UNITED STATES PATENT AND TRADEMARK OFFICE

10/783,499

DETAILED ACTION***Claim Rejections - 35 USC § 102***

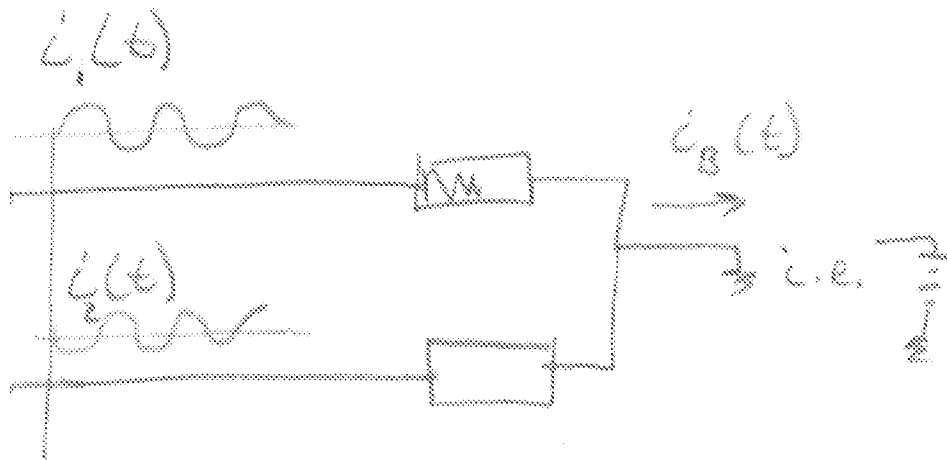
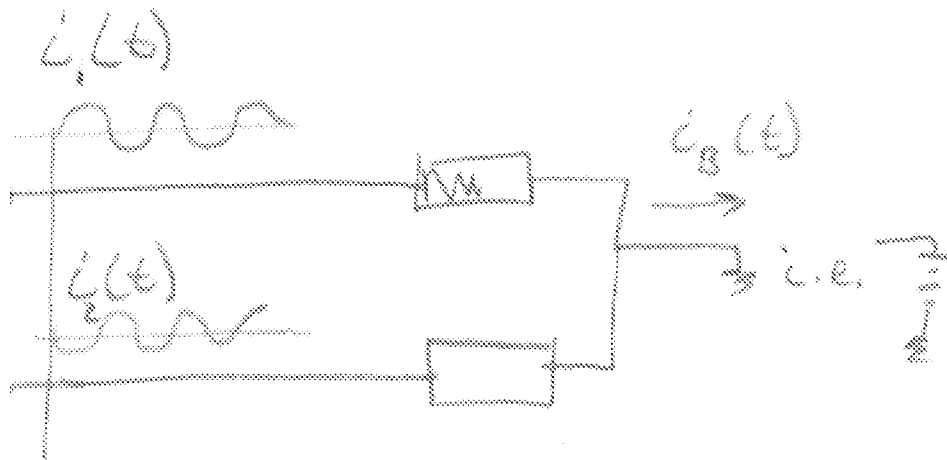
See the two wires that are used to apply the switching signals to the loads as illustrated above.

Speaker illustration number 1.

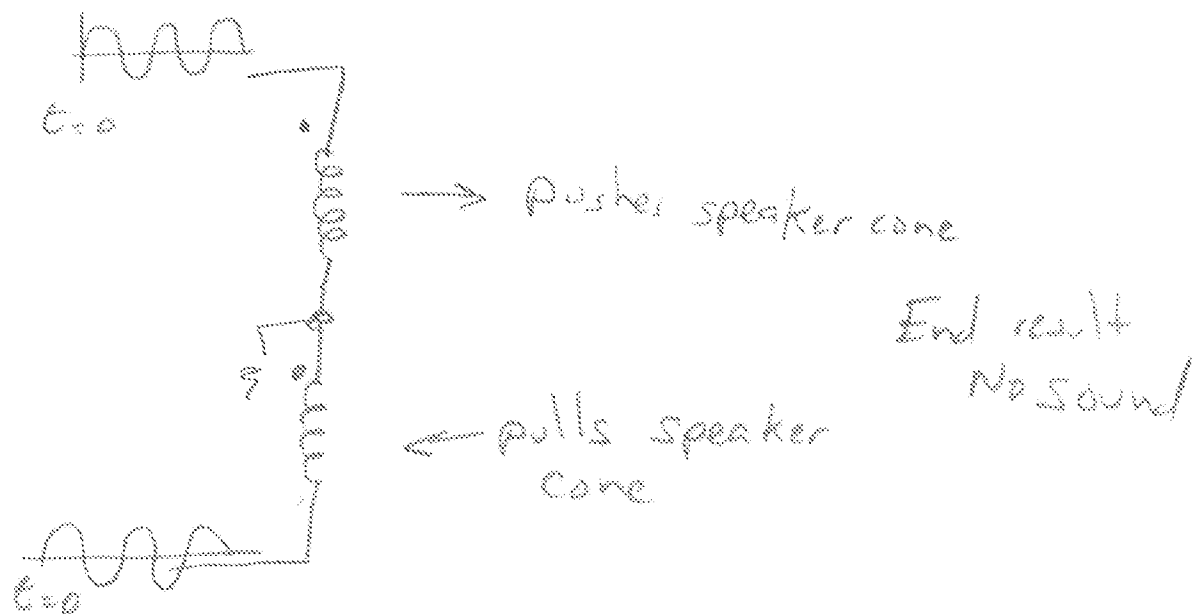
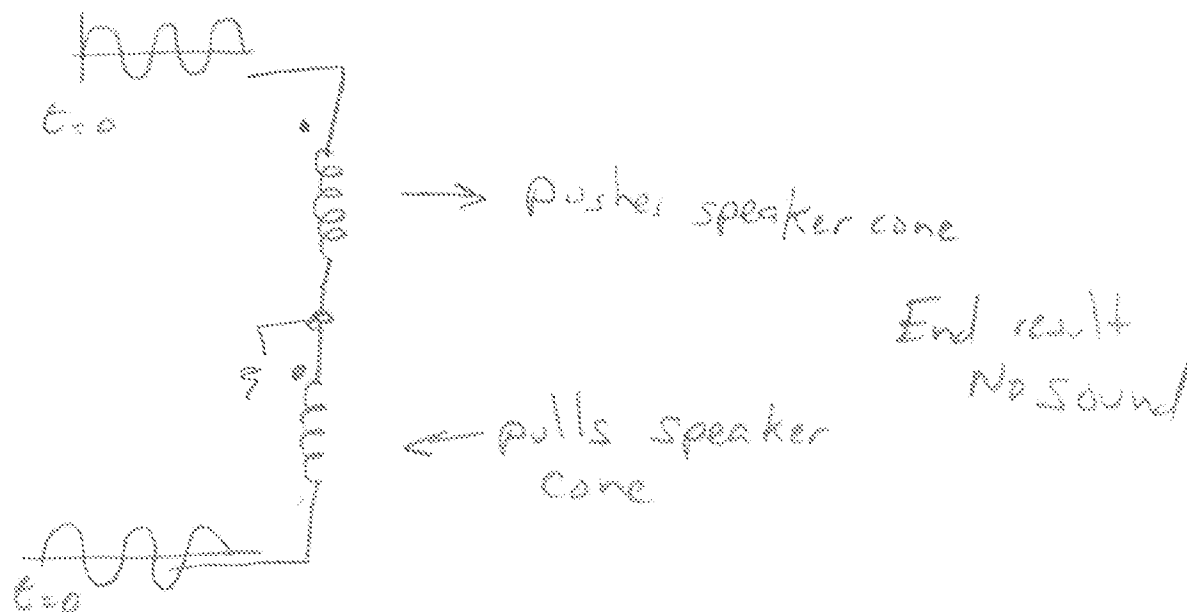
As noted above the baseband signals that are applied to the two loads in the Prokin prior art are out-of-phase just like that of applicant’s invention. This inherently exists because of the “alternative” switching of the inverter transistors in the Prokin arrangement as noted above and more particularly this is further supported by the fact that in one preferred embodiment of Prokin a dual coil speaker is used. Note the “dot convention” of Figure 15. If the base band signals were not complementary or of opposite phase then the speaker would not produce any sound as the voice coils would cancel each other out. See the drawing called “Speaker illustration number 1” below that should help applicant see this fact.

Push Pull illustration.

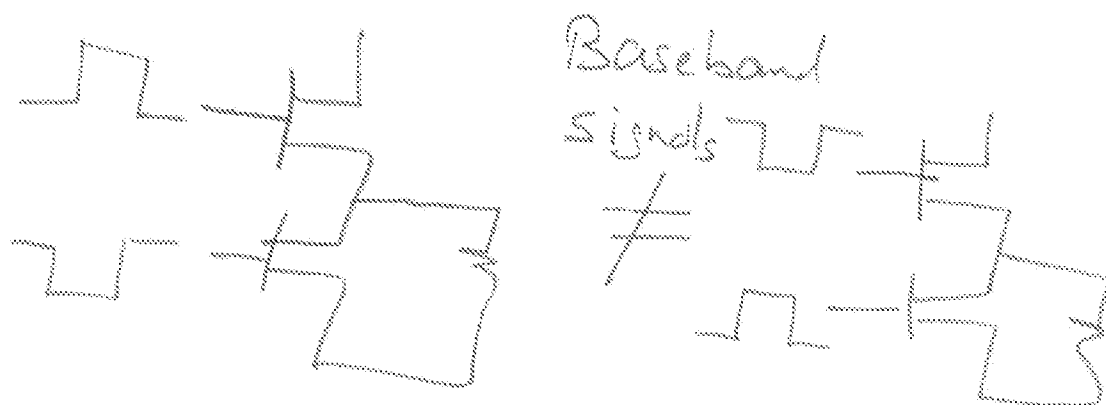
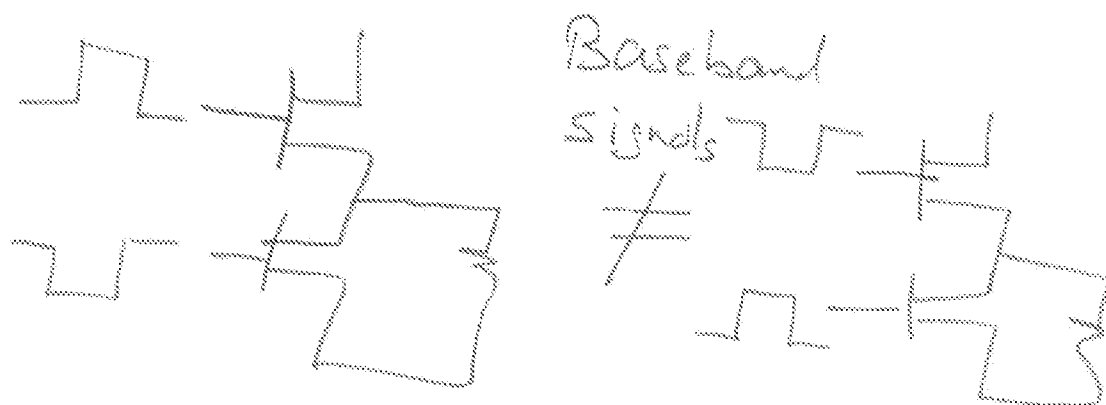
To further illustrate this fact that the baseband currents are of opposite magnitudes note the push and pull nature of the Prokin prior art, i.e. the “alternative” switching. See push pull illustration below.

In the Push Pull illustration note that with the exact opposite PWM signal applied to the "pull" transistor as compared to the "push" transistor the baseband signal just cannot be the same and are in fact 180 degrees out of phase with each other. To explain this in more simple terms note that when you filter out the high frequency signal what you have left is the width of the pulses defining how much the positive magnitude is (Push) and how much the "negative"(ground) magnitude is (pull). When the pull magnitude is at the highest in one push/pull arrangement the Push magnitude is at its highest in the other push/pull arrangement. In other words the baseband signals are opposite or 180 degrees out of phase between the two push/pull arrangements. (Note that the claims are drawn to structure so even if the examiner were to be incorrect in baseband signals are not the same for the two push pull circuits operated in an opposite manner as illustrated in the push pull illustration above, still applying the yet unclaimed disclosed control signals to the prior art does not impart patentability to the structure as the structure is the same and merely applying signals to an old structure that is different from the norm does not make that structure new. It is the same old structure. What applicant will be getting should this application become a patent is the right to exclude others from making the claimed structure. **There must be no "ambiguity" as to what that structure is.** See Halliburton Energy Services, Inc. v M-I LLC, Fed. Cir. 2007-1149. The examiner has constantly pointed to MPEP 2114 where the patent office requires this of the claims. Thus what is needed here in this application is clear limitations of structure to distinguish over the prior art so as to provide a clear indication to the public as to what structure applicant will be allowed to exclude others from making should this application become a patent.)
